Project Name: D.S. and S Minor Subdivision – Final Plat

Subject: Planning Review 12/14/81 - A.D.S. and S Subdivision  
File #103-81

# REVIEW SHEET SUMMARY

FILE NO. 103-81 DUE DATE 12/14/81  
 ACTIVITY DS & S Minor Subdivision  
 PHASE Final Plat ACRES \_\_\_\_\_  
 LOCATION 316 27 3/8 Rd.  
 PETITIONER David & Susan Cyphers  
 PETITIONER ADDRESS 316 27 3/8 Rd., Grand Junction, CO 81501  
 ENGINEER John Ballagh, 1015 N. 7th St., Grand Junction, CO 81501

# D.S. AND S. SUBDIVISION

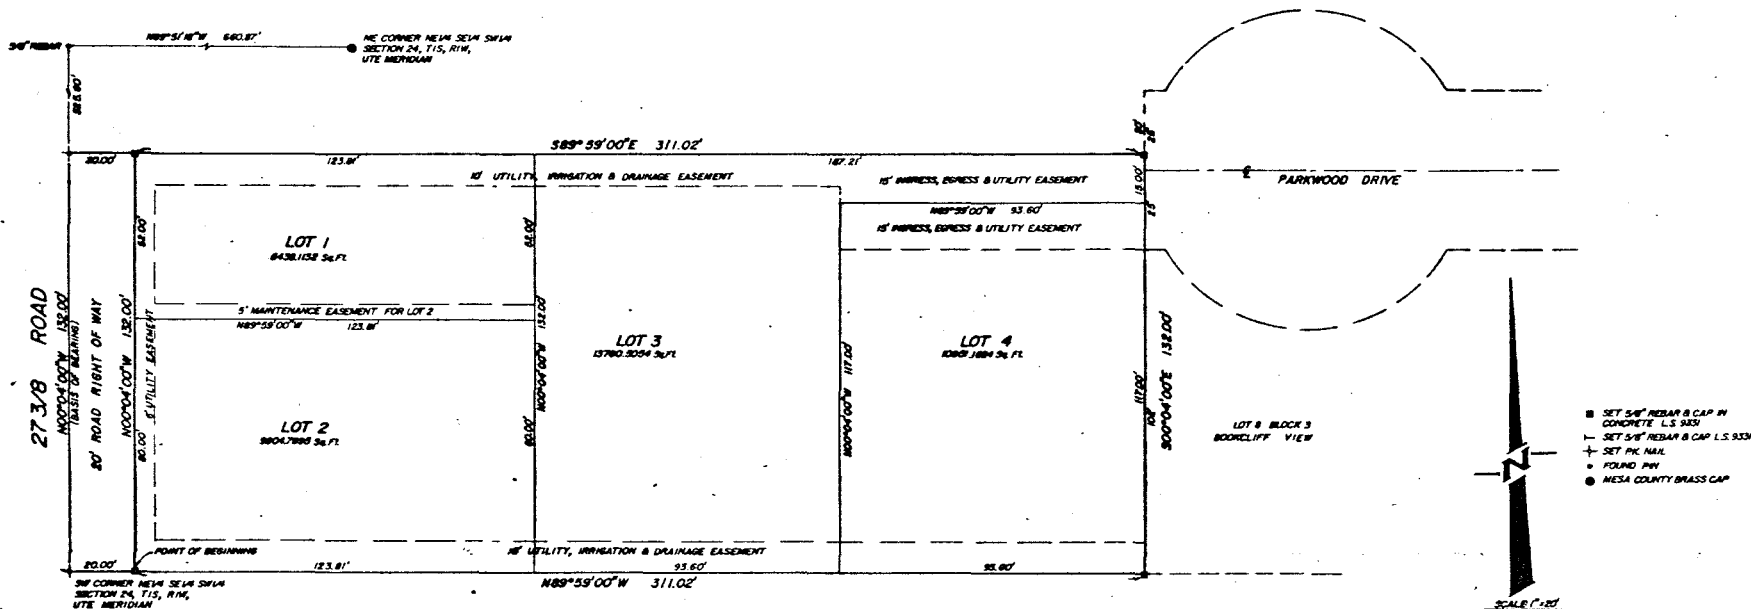
DATE REC.	AGENCY	COMMENTS
12/10/81	Transportation Engineer	It appears that Parkwood Drive is aligned, and was intended, to be extended back into 27 3/8 Rd.. This would complete the loop with Laguna Dr. and provide better access to the area. If this is not done, then there should be one common drive off of the Parkwood Dr. cul-de-sac for both lot 3 and 4, regardless of future owners decisions.
12/11/81	Ute Water	No objections.
12/11/81	City Fire Dept.	<p>Before the fire department can approve this development, we must have additional information.</p> <p>I am unable to determine how you plan to provide access to lots #3 &amp; 4. The existing two fire hydrants in Bookcliff View Subdivision and one on Laguna Drive may not be adequate due to distance and access to the D.S. and S. subdivision.</p> <p>Please submit plans showing access and required fire protection.</p>
12/14/81	City Utilities	<p>Utilities are not shown. How will lot 3 be served? I assume service lines will be run from either Parkwood Drive or 27 3/8 Road. Each structure must have a separate service line.</p> <p>Care should be taken that the 10 foot easement not become a shortcut between Parkwood Drive and 27 3/8 Road. The access to lots 3 &amp; 4 from Parkwood Drive should be a common driveway cut and not a 30 foot "road" off the end of a cul-de-sac, unless a half road right-of-way is given to extend Parkwood Drive to 27 3/8 Road.</p>

<u>DATE REC.</u>	<u>AGENCY</u>	<u>COMMENTS</u>
12/14/81	Public Service	Gas: No objections to final plat. Request developer contact P.S.Co. concerning loads and points of service. HT 12/3/81 Electric: Request the West 10' of Lot #3 be designated utility easement. HBT 12/7/81
12/15/81	City Engineer	27 3/8 Road should be dedicated to have the right-of-way align with Bookcliff View Subdivision to the north and power of attorney for street improvements should be granted. Parkwood Drive should be dedicated from 27 3/8 Road to the cul-de-sac as a 50 ft. right-of-way with improvements to match Parkwood. This was the Planning Commissions intent when Parkwood was built with the stub to the west. This petitioner should construct curb, gutter and sidewalk on the south side and 22 ft. of mat to open the street initially. Sanitary sewers and waterline routings should be adjusted to serve the lots from public lines in Parkwood Drive.

12/15/81	Staff Comments	1) Adequate fire protection should be addressed. 2) Coordinate with Parks and Recreation for open space fee.

The west 10 feet of Lot 3 will be designated as a utility easement as requested by the Public Service Company.

The right of way on 27 3/8 Road is aligned with the dedicated right of way as platted in Bookcliff View Subdivision. A power of attorney will be granted for street improvements to 27 3/8 Road. The power of attorney will be granted after approval of the subdivision, prior to recording the plat.

Parkwood Drive is a cul-de-sac street coming into D.S.&S. Subdivision from the east. Utilities were run into the cul-de-sac as if it were to remain. That is the continued desire, for Parkwood to remain as a cul-de-sac. To run the street through to 27 3/8 Rd. would create a horseshoe/circle street, thereby allowing through traffic in front of those lots presently fronting on a cul-de-sac. The proposal is to front only two more lots onto Parkwood Drive, not open up a through street. The two additional lots will present building sites for two single family detached dwellings on lots slightly larger than in Bookcliff View Subdivision.

A common ingress-egress easement for Lots 3 & 4 will allow a wider than normal common drive. The Fire Department and the Cyphers are in agreement that the recommendation of the City Traffic Engineer is reasonable and can be accomplished. The improvement of a wide (20') common driveway should be placed after the individual service taps have been made. A note on the plat calling for the common drive and stating minimum width can be added to the plat.
